Access Compliance Report

Public Rights-of-Way

(Curb Ramps)

Intersection ID: 51509	Main Street: EASTFIELD_PARK_DR	Cross Street: NETHERTON_LN	Location: E
ADA ID: 300492C3A040	Ramp Type: PerpDiag	Initial Pass/Fail: Fail	Overall Compliance: No
Severity Score: 8.75			
Codes/Mitigation Info/Possible Solution		Field Measurements/Component Compliance

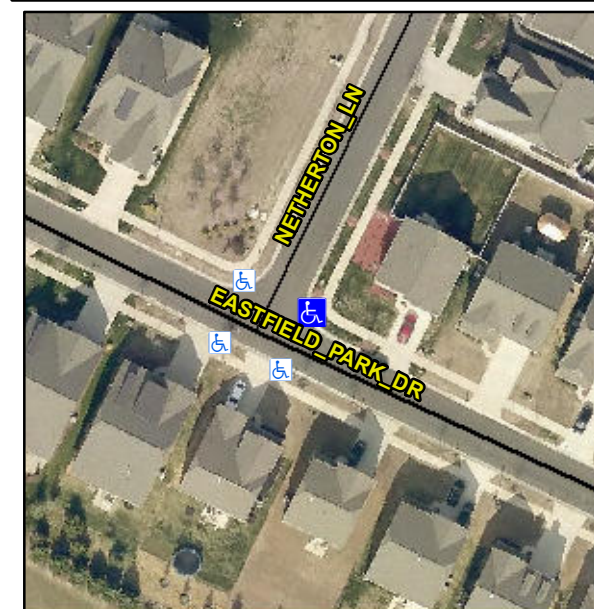
Surveyor Notes:

Not Found, R304.5.1

Remove & Replace Curb Ramp With Two New Directional Ramps or Equivalent.
